April. 2024

Leimac Ltd.
LED Lighting Group
Sales Department
TEL : +81-77-585-6771
FAX : +81-77-585-6773

Notice of discontinued product of Connection Cable

● Discontinued : I-CB-S■R-DNEL2 series

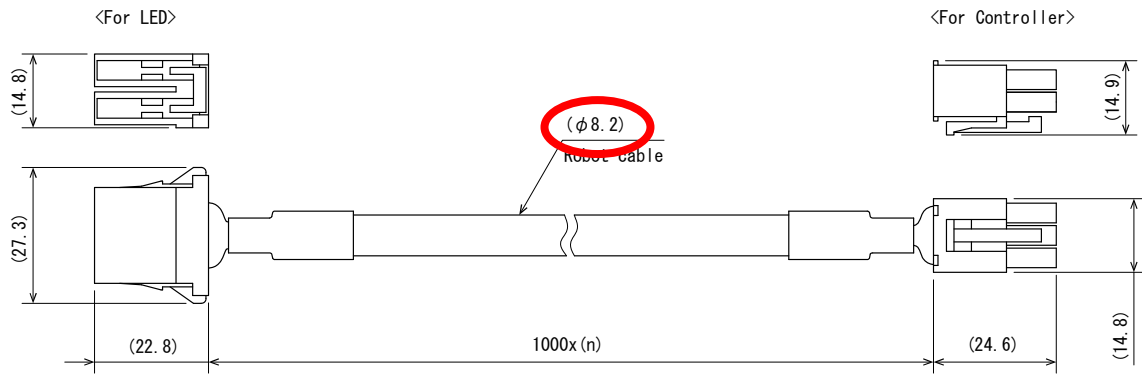
In the succeeding model, the diameter of the cable to be connected to the light will change from $\phi 8.2$ to $\phi 9.2$.

The minimum bending radius will also be 56mm instead of 50mm.

● Successor model : I-CB-S■R-DNC2 series
